Expanding the Economic and Innovation  
Opportunities of Spectrum Through Incentive  
Auctions

GN Docket No. 12-268

**COMMENTS OF QUALCOMM INCORPORATED ON PUBLIC NOTICE  
TO SUPPLEMENT THE RECORD ON THE 600 MHz BAND PLAN**

June 14, 2013

**Figure 12 in *Incentive Auction NPRM***

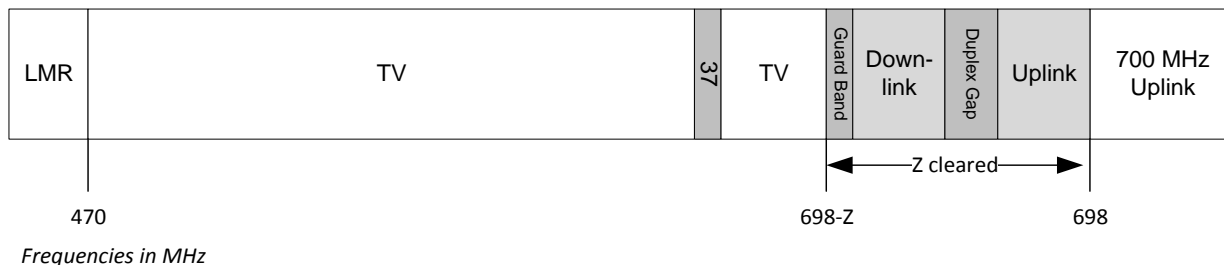
The 2 x 25 MHz FDD band plan with a duplex gap of at least 10 MHz can be readily incorporated into smartphones and other mobile devices in form factors comparable to the

devices in use today and using RF components that will become available in the very near future. A duplex gap of at least 10 MHz is needed to avoid interference between mobile downlink and uplink based on the attenuation filters that Qualcomm understands will become available by the time that the auction ends, based on known technology. A guard band of approximately 10 MHz between the last full power (*i.e.*, 1 MW) TV station and the downlink block is the minimum needed to prevent a TV station from saturating a mobile device that is trying to receive.<sup>6</sup>

**Figure 1.** Qualcomm's Recommended 600 MHz Band Plan

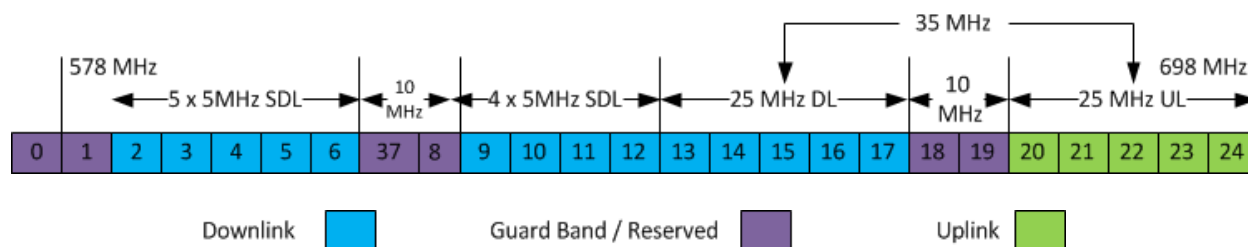
Based on its detailed and multi-faceted technical analyses conducted over the past nine months, Qualcomm is at this point in time even more confident about the technical feasibility of using the 600 MHz band for FDD operations, that is, with 2 x 25 MHz situated in the uppermost portion of the band along with a 10 MHz duplex gap, with any additional spectrum allocated for Supplemental Downlink (“SDL”) operations. Such a plan is shown in Figure 1 below.

SDL is particularly useful because the traffic on mobile networks is increasingly asymmetrical.<sup>18</sup> Mobile broadband traffic data shows that the ratio of downlink to uplink can be 10:1 or greater.<sup>19</sup> And, by placing SDL spectrum blocks adjacent to the downlink portion of the FDD portion of this band plan, there is no need to provide a guard band between the downlink blocks, as the FCC has recognized.<sup>20</sup> By locating the uplink portion of the 600 MHz band in the uppermost portion of the band, there also is no need to provide a guard band between the 600 MHz uplink band and the Lower 700 MHz A Block — because like operations in adjacent bands are spectrally compatible, as the FCC well knows.<sup>21</sup>

### **Down from 51 Reversed, more than 84 MHz cleared**

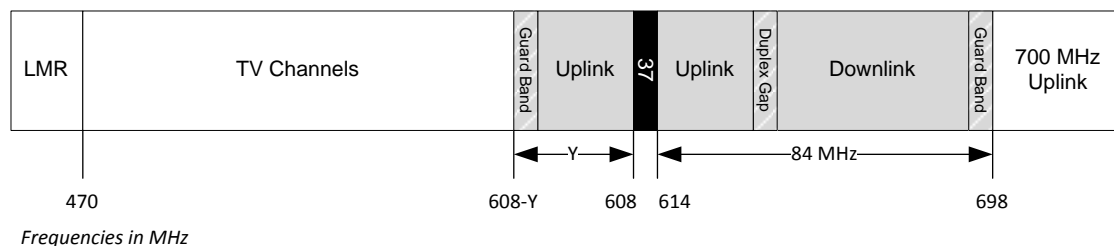
Qualcomm explains in this section of its comments the many technical problems that would be created by implementation of the DF51 Reversed band plan.

As Qualcomm explains in Section I.A above,<sup>24</sup> the 25 MHz block of spectrum at the upper end of the 600 MHz band is best suited to support uplink operations, and this uplink block can be placed directly adjacent to the existing Lower 700 MHz (uplink) A block in the straight DF51 band plan without any guard band.

The DF51 Reversed band plan, in contrast, would place downlink spectrum at the upper end of the 600 MHz band and thus necessitate the use of a guard band of approximately 10 MHz at the uppermost portion of the band to protect the mobile device downlink operating in the

This 10 MHz guard band would waste 40 percent of the spectrum (*i.e.*, 10 MHz out of the 25 MHz) that is best suited for uplink operations and thus not make optimal use of that spectrum.

Moreover, if the guard band were less than 10 MHz, there likely would be efforts to place restrictions on the Band 12 (Lower 700 MHz A block) uplink via the 3GPP standards process.

The DF51 Reversed band plan would place uplink operations in a portion of the band that would create intra-device interference with other bands that will be simultaneously active on the device, as explained in Section I.A above. These bands include 2.4 GHz unlicensed Wi-Fi operations, GPS and GNSS bands used for position location, and licensed PCS, WCS, and BRS/EBS operations, among others. Limiting the ability of 600 MHz mobile devices to operate simultaneously at 2.4 GHz for unlicensed Wi-Fi operations or the foregoing positioning bands would impair the value of the auctioned spectrum. And, preventing 600 MHz devices from using CA along with the PCS, WCS, and BRS/EBS bands also would impair the value of the spectrum.<sup>26</sup> The DF51 Reversed band plan also introduces the possibility of intermodulation products interfering with the mobile device uplink because it places mobile uplink operations in between TV stations and mobile downlink operations.

Placing uplink operations in the lower portion of the 600 MHz band adjacent to Channel 37 would increase the potential for interference to WMTS and radio astronomy operations and may require the addition of guard bands around Channel 37 to protect such operations. This problem is not present with the straight DF51 band plan that locates downlink operations directly adjacent to Channel 37.

The market variation diagrams on page 4 of the WTB PN for the DF51 Reversed band plan show a collection of band plans with variable uplink bands. A variable uplink band would be substantially less amenable to accommodating market variation when compared to a variable downlink band. In fact, the distances at which a full power TV broadcast signal will interfere with mobile broadband uplink operations is much greater than the distance at which full power TV broadcast signals will interfere with mobile downlink operations. Based on Qualcomm's calculations, the distances are approximately 500 km (or 310 miles) for TV to mobile uplink and as compared to approximately 100 km for TV to mobile downlink.

The FCC should not waste valuable 600 MHz spectrum that is ideal for uplink on a guard band, and the agency should not take any action that could jeopardize Band 12 uplink operations.
